Open Muscle

Sheet: /
File: OM-FlexGrid-Rigid-PCB.kicad_sch

Title: Open Muscle FlexGrid Rigid PCB V3

Charging

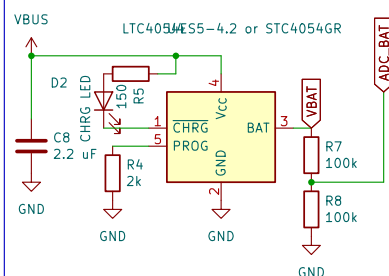
Program Pin 5.2K too High
Use 2.7K Instead
